This amendment updates the reactor pressure-temperature limits to eight effective full power years, based on the analysis of the first surveillance capsule. That portion of your amendment request dealing with deletion from the TSs of surveillance requirements for reactor vessel irradiation specimens has been addressed in Amendment 80 to the operating license.

CRYSTAL RIVER UNIT 3 NUCLEAR GENERATING PLANT

Amendment No. 82
License No. DPR-72

SAFETY EVALUATION BY THE OFFICE OF NUCLEAR REACTOR REGULATION
SUPPORTING AMENDMENT NO. 82 TO FACILITY OPERATING LICENSE NO. DPR-72
FLORIDA POWER CORPORATION, ET AL.
CRYSTAL RIVER UNIT NO. 3 NUCLEAR GENERATING PLANT
DOCKET NO. 50-302

REACTOR COOLANT SYSTEM PRESSURE-TEMPERATURE LIMITS FOR HEATUP FOR FIRST 8 EFY

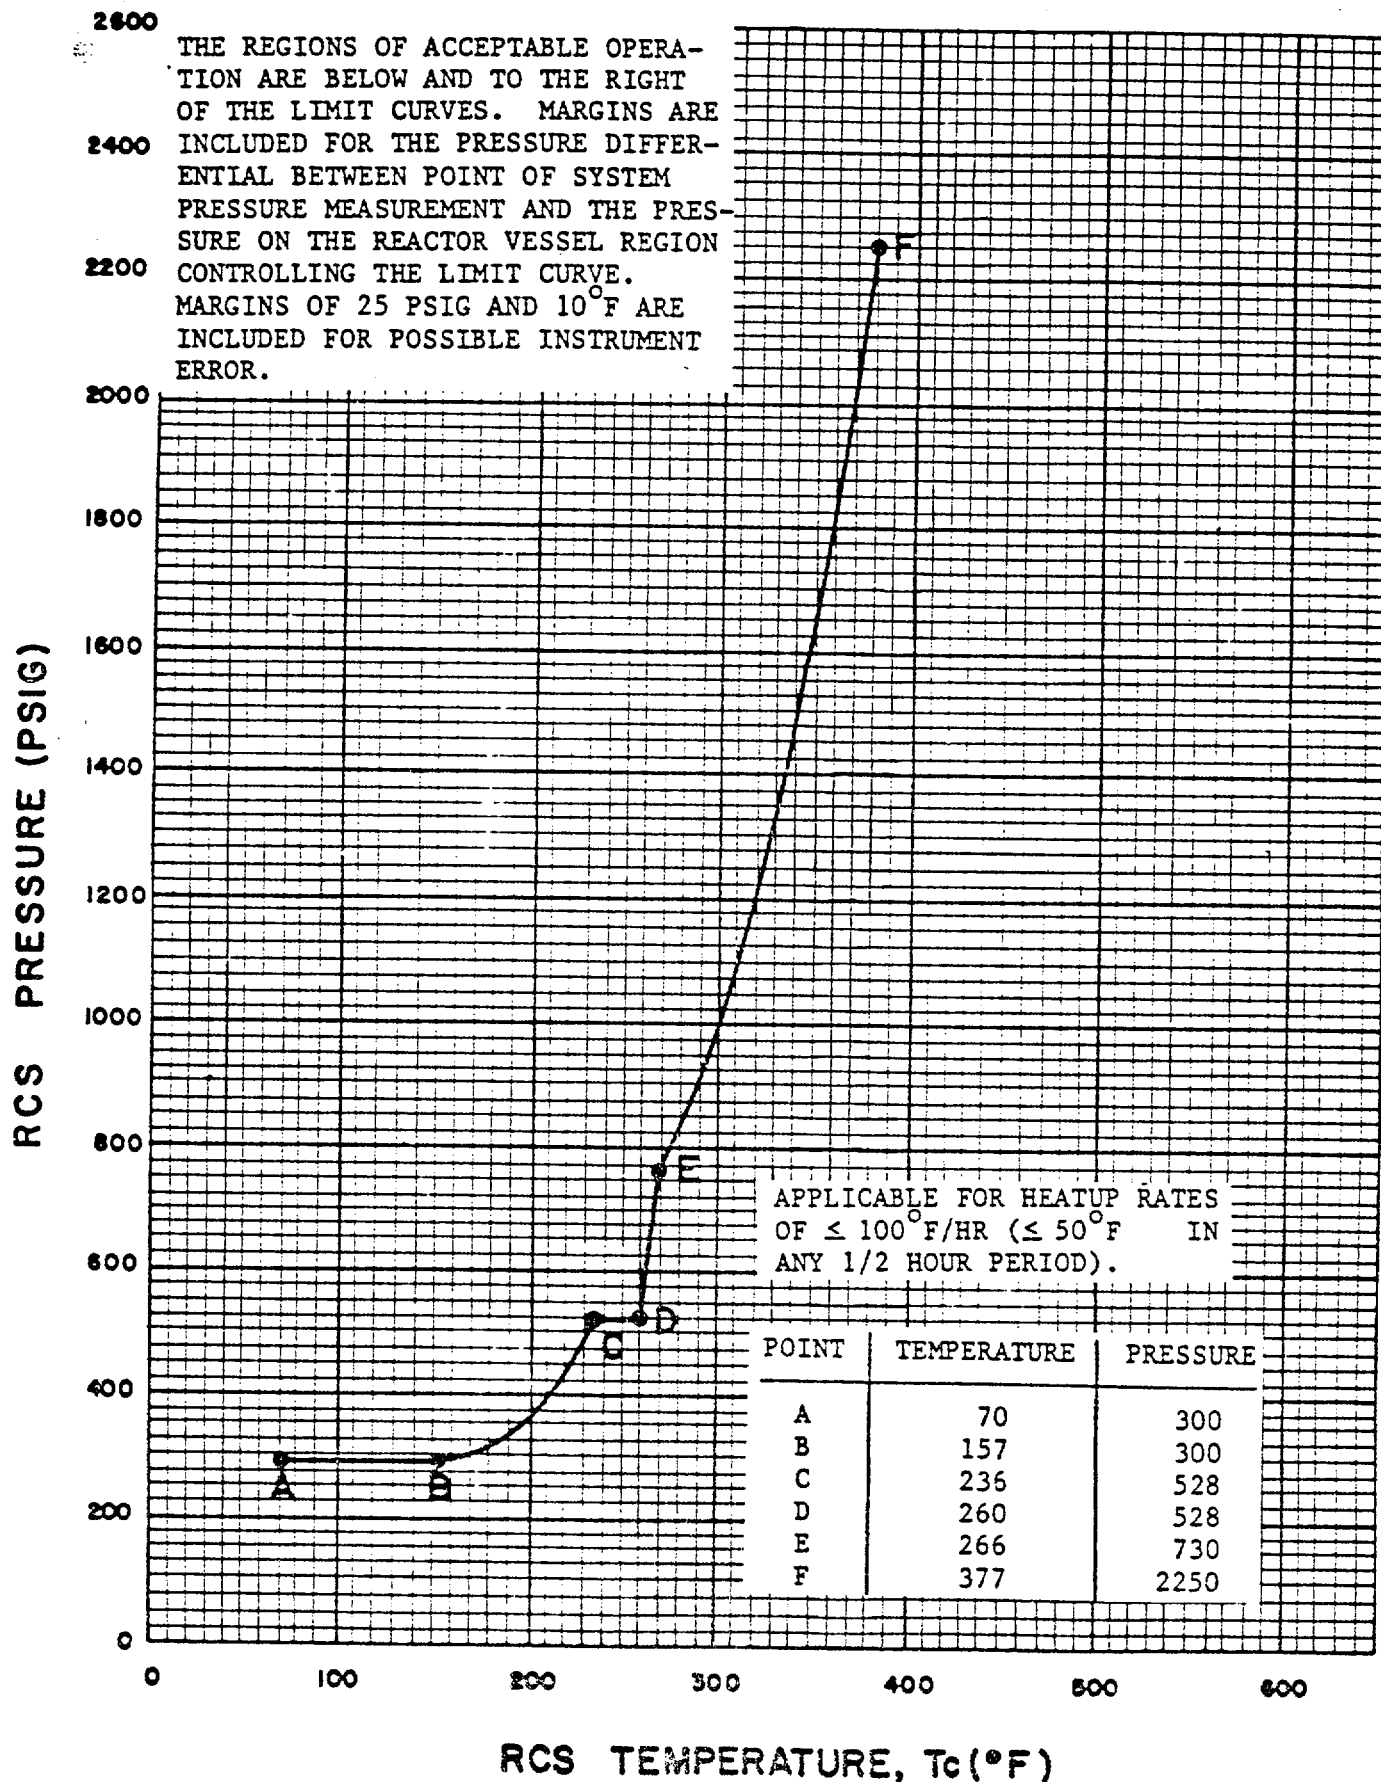
The heatup limit curve, Figure 3.4-2, is a composite curve which was prepared by determining the most conservative case, with either the inside or outside wall controlling, for any heatup rate up to 100°F per hour. During cooldown, similar types of thermal stress occur. Thus, the cooldown limit curve, Figure 3.4-3, is also a composite curve which was prepared based upon the same type analysis as the heatup curve with the exception that the controlling location is always the inside wall where the cooldown thermal gradients tend to produce tensile stresses while producing compressive stresses at the outside wall. Additionally, during cooldown and heatup at the higher temperatures, the most conservative limits are imposed by thermal and loading cycles on the steam generator tubes. These limits are the vertical segments of the limit lines on Figures 3.4-3 and 3.4-4, respectively. (These limits will not require adjustments due to the neutron fluences.)

The licensee has also proposed to delete the criticality curve from Figure 3.4-2. This is acceptable since the requirements of TS 3.1.1.4 continue to apply and will assure that criticality will not occur at unacceptable conditions of temperature and pressure.

We used the method of calculating pressure-temperature limits in USNRC Standard Review Plan 5.3.2, NUREG-0800, Rev. 1, July 1981, to evaluate the proposed pressure-temperature limits. The amount of neutron irradiation damage to the beltline materials was estimated using the method recommended by the staff in Regulatory Guide 1.99, Rev. 1. The amounts of copper and phosphorus in the limiting CR-3 beltline weld were the values reported in Topical Report BAW-1511P. The neutron fluence used to predict neutron irradiation damage was based on a .81 normalizing factor. Our conclusion is that the proposed pressure-temperature limits meet the safety margins of Appendix G, 10 CFR 50, for eight EFPY and are therefore acceptable and may be incorporated into the plant's Technical Specifications.
